ADD 3-2. 3 01/29/96

GREENFIELD AQUATIC CENTER
REFEED REMOTE ELECTRICAL SERVICES
E5

PROJECT NAME:
GREENFIELD AQUATIC CENTER

- SINGLE LINE DIAGRAM

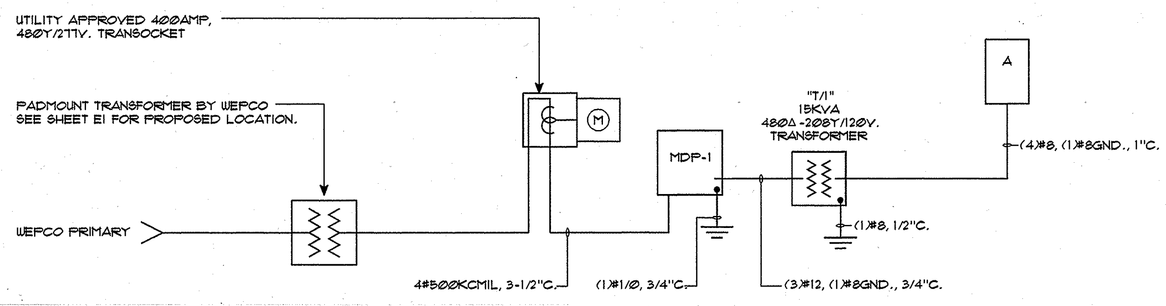
ADD (1) 60 Ampere, 3 pole, circuit breaker to panel MDP1.

ADD (2) 100 Ampere, 3 pole, spaces only to panel MDP1.

1/E5 ELECTRICAL DEMOLITION - NORTHEAST PICNIC SHELTER TRANSFORMER POLE

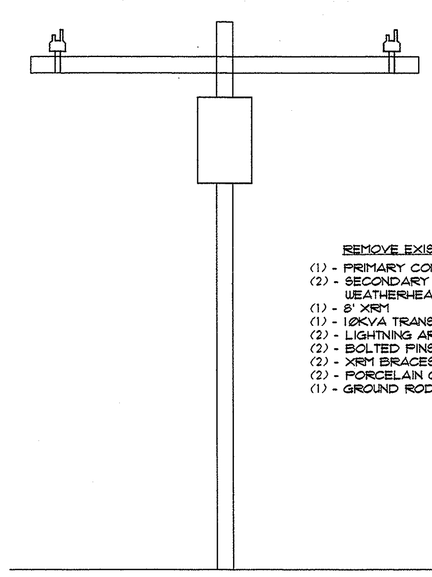
REMOVE EXISTING POLE

(1) - PRIMARY CONDUIT RISER
(2) - SECONDARY CONDUIT RISERS & WEATHERHEADS
(1) - 8' XRM
(1) - 10KVA TRANSFORMER *
(2) - LIGHTNING ARRESTORS
(2) - BOLTED PINS
(2) - XRM BRACES
(2) - PORCELAIN CUTOUTS
(1) - GROUND ROD & GROUND WIRE

* OIL FILLED TRANSFORMER

POOL MECHANICAL EQUIPMENT BUILDING POWER & SYSTEMS PLAN

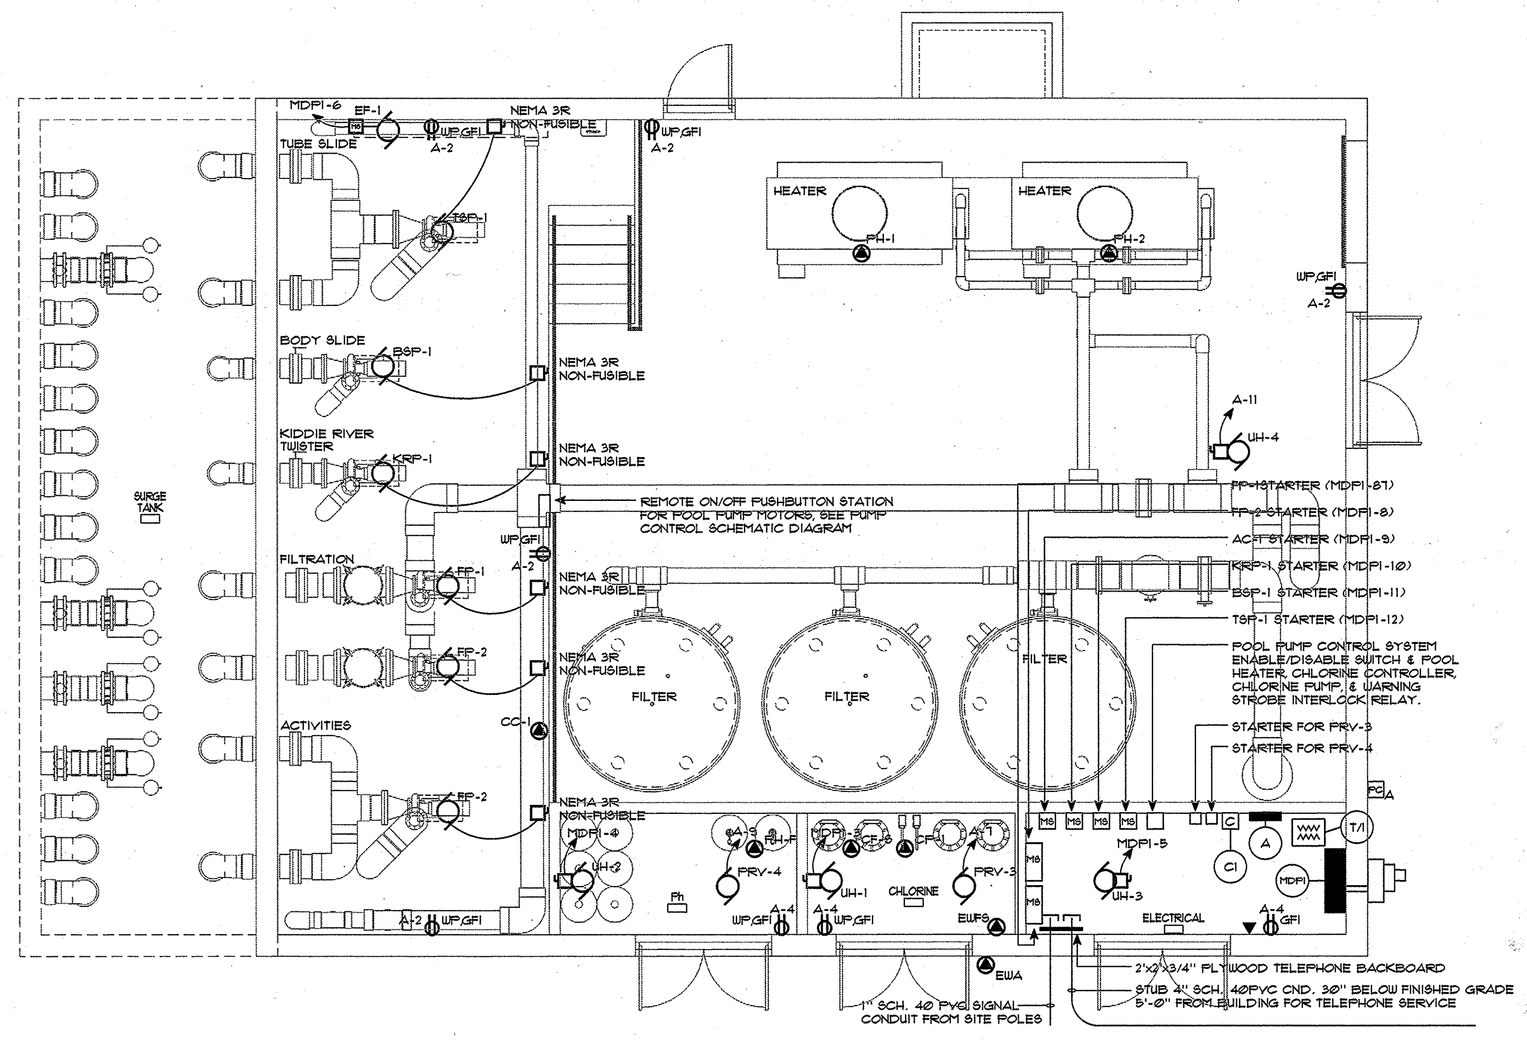
ADD (1) 20 Ampere, 1 pole circuit breaker to panel A for "Irrigation Controller."

PROVIDE 20 Ampere, 120 volt, single phase circuit to irrigation controller. Refer to Sheet L7 for detailed requirements and additional work required by EC for irrigation system. 3
